# 6-8 John Street and 13B Church Avenue, Mascot

Statement of Environmental Effects – Section 4.55(2) Modification

On behalf of  
*Iglu No. 211 Pty Ltd*  
December 2020 (Amended 16 February 2021)

**Figure 4.** Proposed Level 10 Plan – Retention of rooftop space (extract from DA03.010\_L10)  
Source: Bates Smart

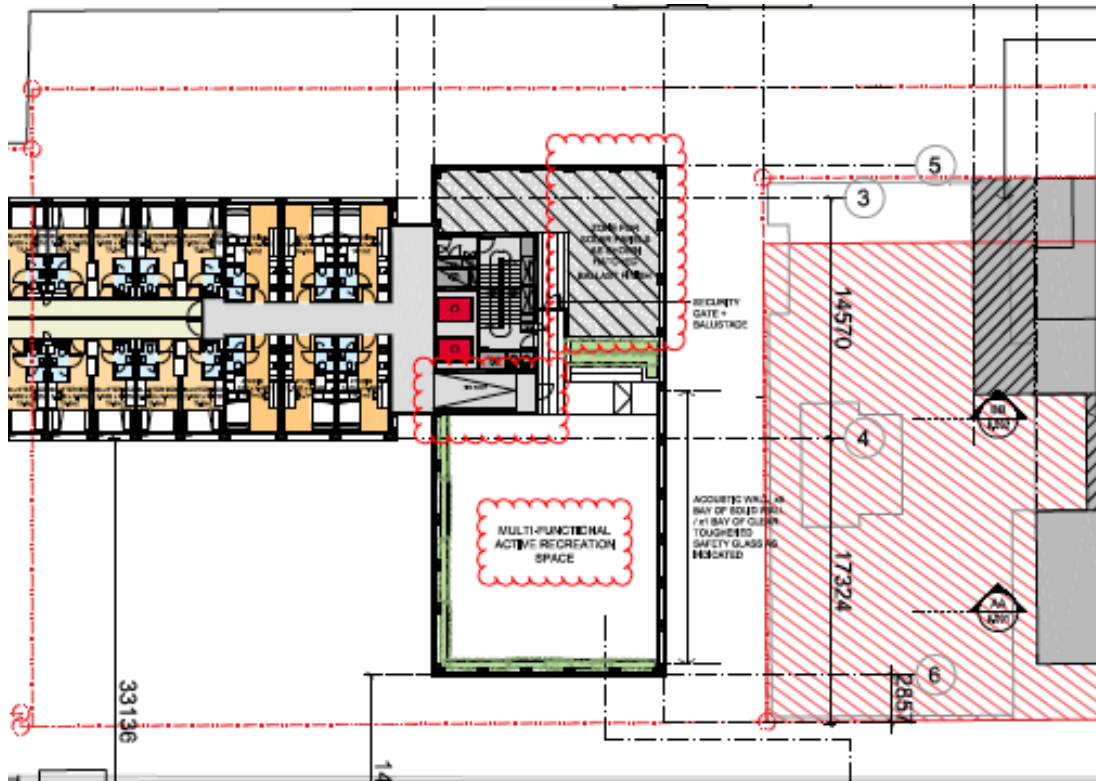
### 2.2.1 Deletion of basketball court and replacement with communal open space

Condition 44 provisions the deletion of the basketball court prior to the issue of a construction certificate with the rooftop to remain as a communal open space. The applicant seeks to meet the requirements of the condition by maintaining the rooftop as communal open space to be used for light active recreation and subsequently delete the condition to reflect this. Whilst the basketball court has been deleted as required by the Condition 44, it is considered that the resultant communal open space should still be focused on creating opportunities for outdoor exercise on the following grounds:

- Consistent with Condition 67, photovoltaic cells will continue to be integrated on the rooftops. The solar panel zone will be separated from the level 10 communal space via a security balustrade and gate;

- Additional measures are proposed to be installed to mitigate and manage noise generated by uses on the terrace. These comprise the installation of a solid sound barrier wall on the northern façade of the recreation space (only) and will be comprised of five (5) bays of solid wall and one (1) bay of clear toughened safety glass. The overall height of the proposed development will remain unchanged from the approved plans. As detailed in the Acoustic Report as lodged with the original DA, acoustic noise travels in a line of sight and upward. Any impact to the neighbouring residences above the roof of the northern tower (potentially at 13A Church Avenue) have been mitigated by the installation of the acoustic barrier (while noting that all other neighbouring residences are below the level of the northern rooftop);

Therefore, this modification seeks to delete the basketball court and replace it with a communal open space providing for active outdoor exercise.
